City of Portland, Maine – Building or Use Permit Application 389 Congress Street, 04101, Tel: (207) 874-8703, FAX: 874-8716 Permit No: 99024 **Location of Construction:** Phone: Owner: 772-2088 Delores Heariksson IAB 16 Austin St Owner Address: Lessee/Buyer's Name: Phone: BusinessName: PERMIT ISSUED Rermit Issued: Phone: Contractor Name: Address: Eastern Shore Home Improvements l Birkdale Ed Comberland, Ne MAR 2 4 1999 **COST OF WORK:** PERMIT FEE: Proposed Use: Past Use: 3,000.00 35.00 INSPECTION: **FIRE DEPT.** □ Approved 1-fam Same Use Group: U Type: 59 ☐ Denied CBL: 140-7-021 Zone: BOCA 96-THE Signature: THE Signature: Zoning Approval: Proposed Project Description: PEDESTRIAN ACTIVITIES DISTRICT (PA.D.) Action: Approved Special Zone or Reviews: Car Port 10 x 22 Approved with Conditions: □ Shoreland Denied □ Wetland ☐ Flood Zone □ Subdivision Date: Signature: ☐ Site Plan maj ☐minor ☐mm ☐ Permit Taken By: 22 March 1999 **Zoning Appeal** Scott State and Federal rules. Eastern Share Bldgs ssuance. False informa-□ Variance This permit application does n ☐ Miscellaneous Building permits do not inclu ☐ Conditional Use Building permits are void if w □ Interpretation ☐ Approved tion may

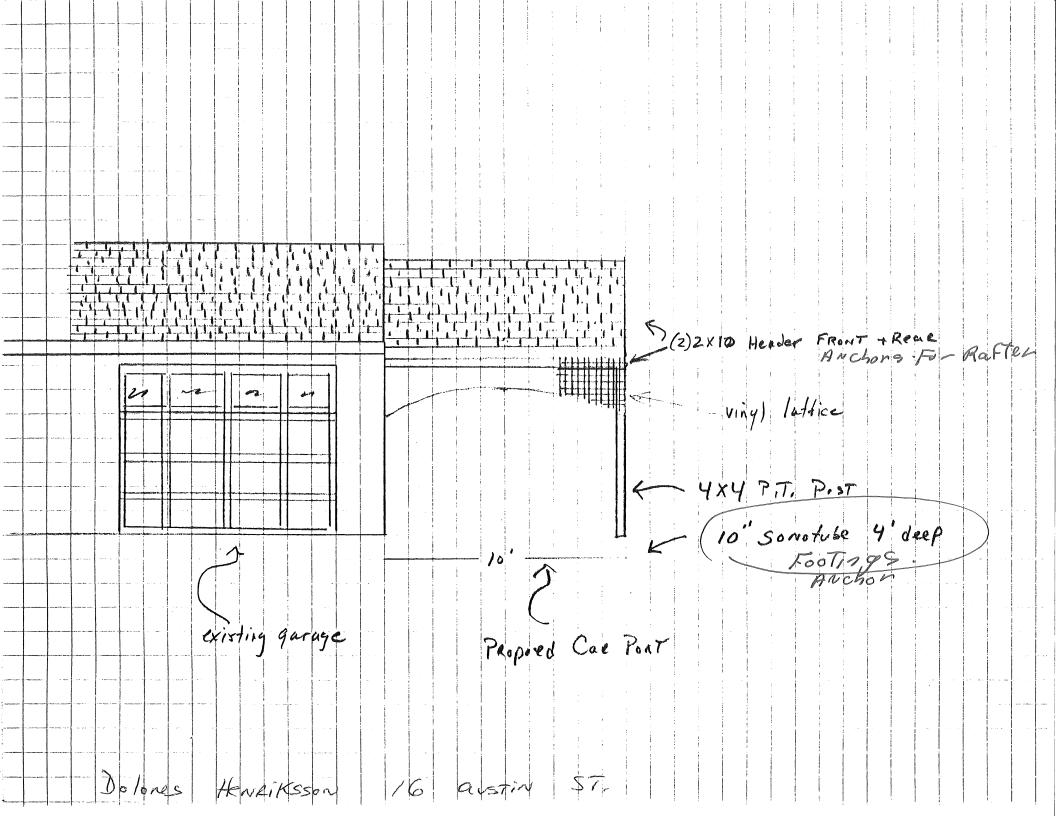
| Applicant: Scotl - Ext. Thre Home Tof Date: 3/28/98 |
|---|
| Front Yard - 25/veg - 26 show |
| Rear Yard - 25 (- g - 60) Show |
| Side Yard - 0' Veg - 12'9" Show |
